# OLIVE | JUDD

Re: 2851 and 2901 NE 9<sup>th</sup> Court Project, also referred to as Ocean Park Hotel  
and Residence; UDP-S21031 (the “Project”)

**SUBJECT:** Ocean Park Hotel – Traffic Study Review

Figure 2: Proposed ITE Reduction vs Actual Trips occurring at Restaurant (AM & PM Peak)

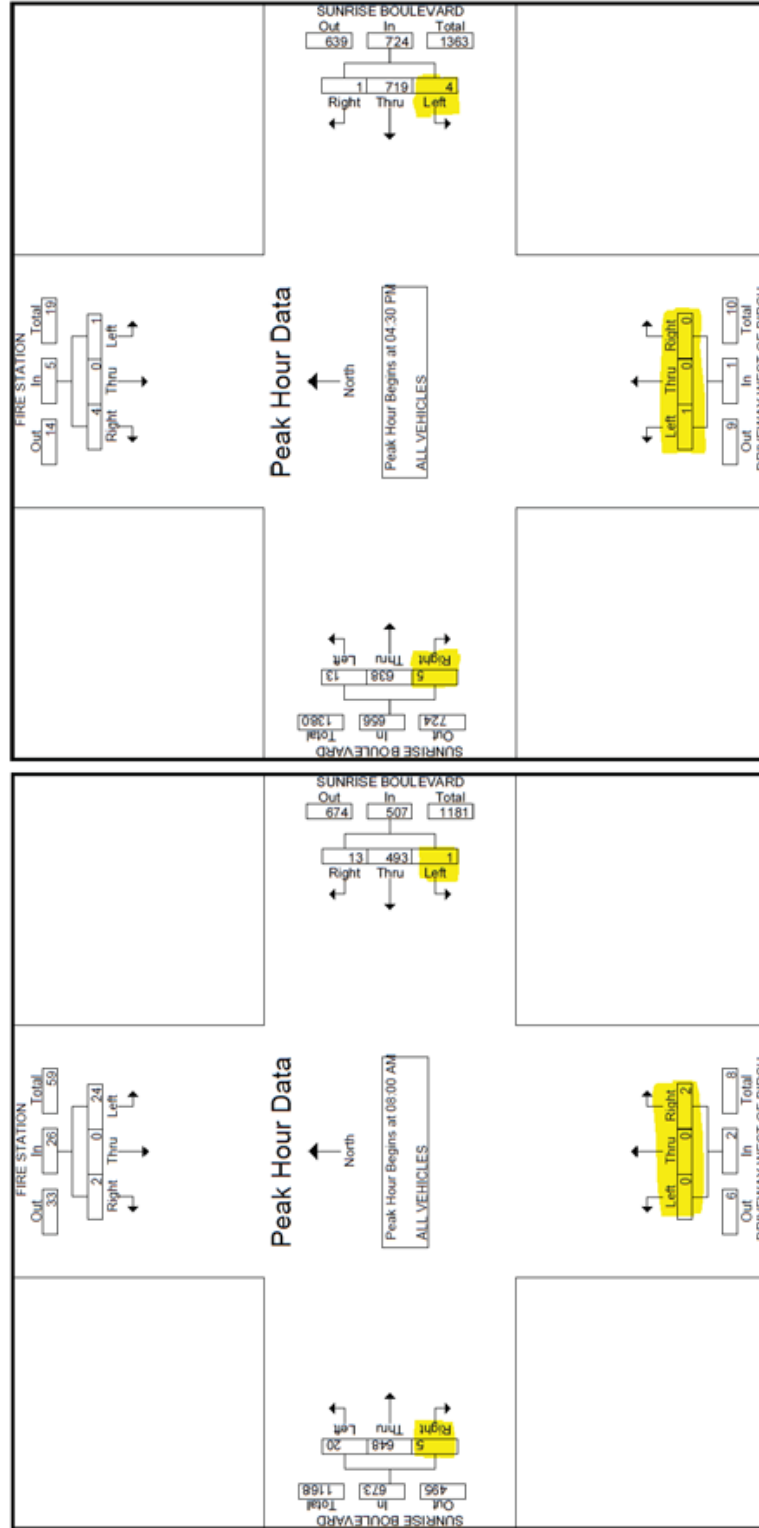
A field review was performed on March 3<sup>rd</sup>, 2022 during the afternoon to assess the site and existing conditions. One of the concerns as given by the community is that the existing site was underperforming and had vacant buildings, in particular, the existing restaurants which will be identified here forth as the Italian restaurant and the Mexican restaurant, respectively.

Based on the field review it was determined that both the Italian and Mexican restaurants were permanently closed-vacant as given by the removal of signs, lack of activity and closed shutters. In the case of the Mexican Restaurant, pictures are provided showing the inside with no condition to service patrons.

As part of the desktop review, this vacancy is further confirmed as given by DC Engineering report that shows Turning Movement Count (TMC) data at the intersection of East Sunrise Boulevard and the Fire Station confirming that both restaurants were closed at the time of data collection. Volumes entering and exiting the parking lot during the AM and PM peak hour in the TMCs show a significant lack of activity for this site. **Figure 2** shows the comparison of the ITE Existing Trip Generation being proposed by DC Engineering Inc. in relation to the collected TMCs.

Therefore, it is highly advised to remove the credited High-Turnover (Sit Down) Restaurant trips from the existing condition analysis in order to reflect actual impacts to the intersections in concern. Documentation of field visit and vacant restaurants is provided in **Appendix B**.

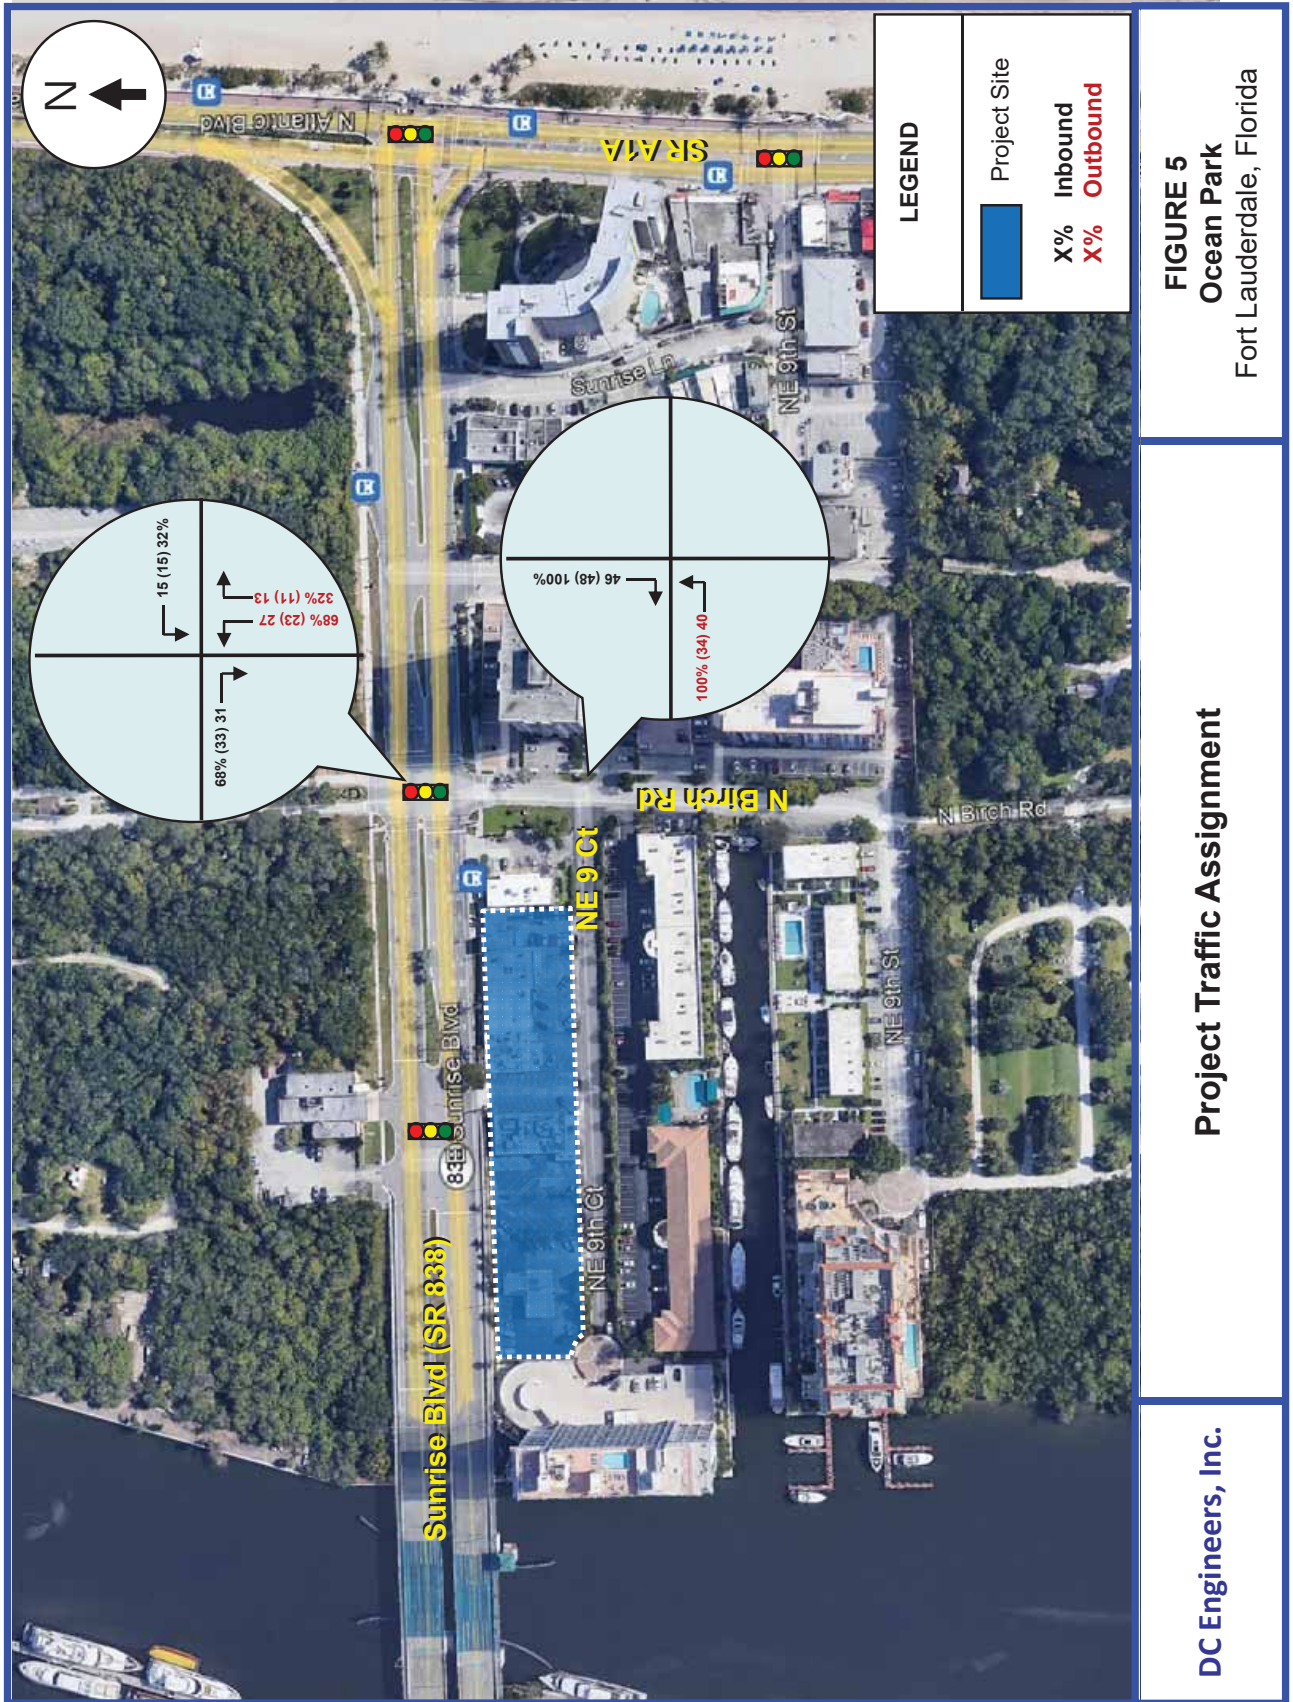
A review of the trip distribution was performed for the TIS report. The TIS trip distribution section from the report indicated that “A distribution of 68 percent to and from the west and 32 percent to and from the east was utilized”. The report also states “the distribution and assignment of project-related vehicle trips are based on current travel patterns documented at the intersection of Sunrise Boulevard (SR 838) and Birch Road”. However, no direct documentation of how these percentages were determined at the time of this review.

As such, distribution appears to be estimated based on the TMCs collected at the intersection approach along North Birch Road and East Sunrise Boulevard. **Figure 3** below provides the collected TMCs and approach percentages recommended to be used.

Based on these movements, approximately 66% of trips will arrive and depart from the west along East Sunrise Boulevard. Conversely, 34% of the trips will arrive and depart from the east along East Sunrise Boulevard. It is recommended that the report provide calculations for the distribution utilized or redistribute based on the above calculations.

**Table 6.2 Unconstrained Internal Person Trip Capture Rates for Trip Destinations within a Mixed-Use Development**

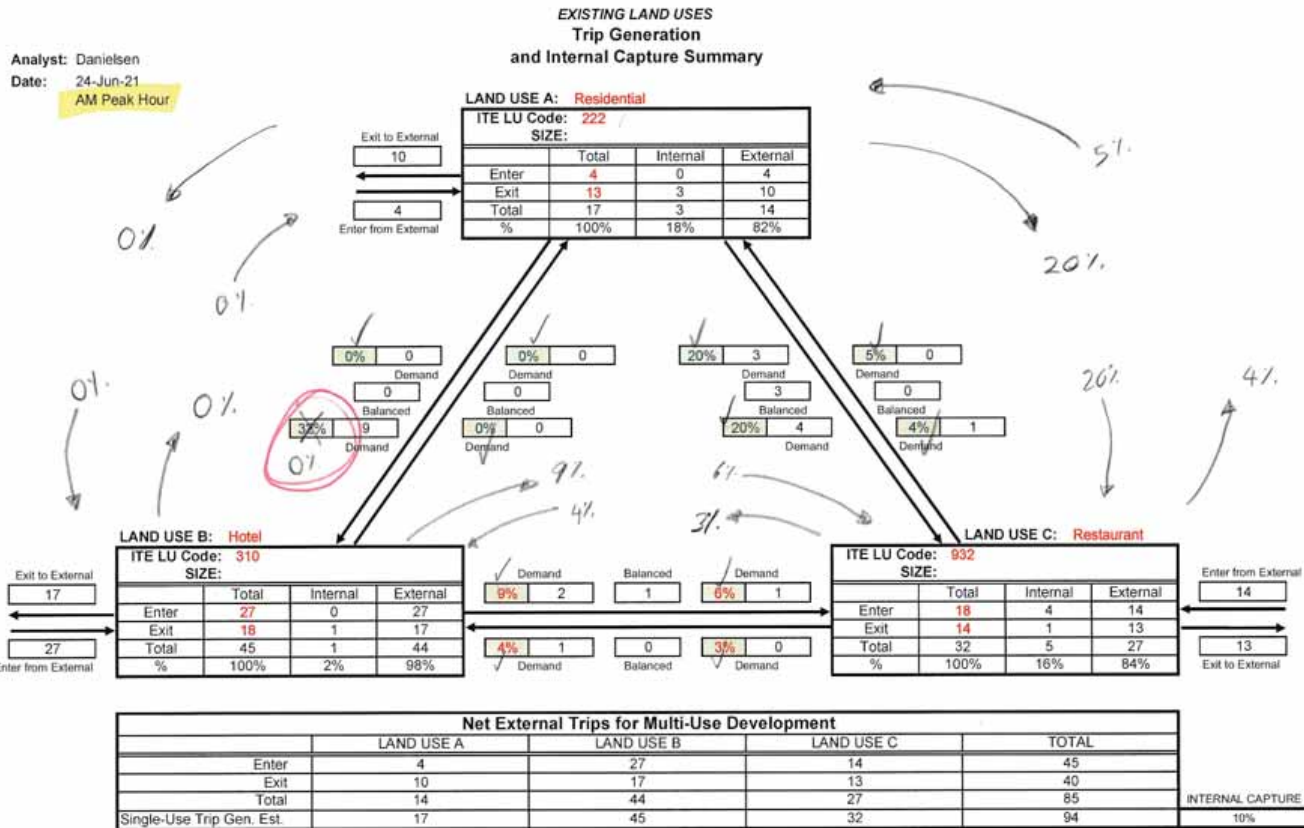
**Reassessment of Internal Trips (O-D) Analysis:** A review of the Internal Trips Origin-Destination analysis was performed using the ITE Trip Generation handbook, 3rd edition as specified in the report. Based on Table 6.1 and Table 6.2 of the ITE Trip Generation handbook discrepancies were noted for the PM peak analysis and it is recommended to re-evaluate the internal capture. **Appendix C** of this document provides documentation and markups for the Internal Trips Analysis.
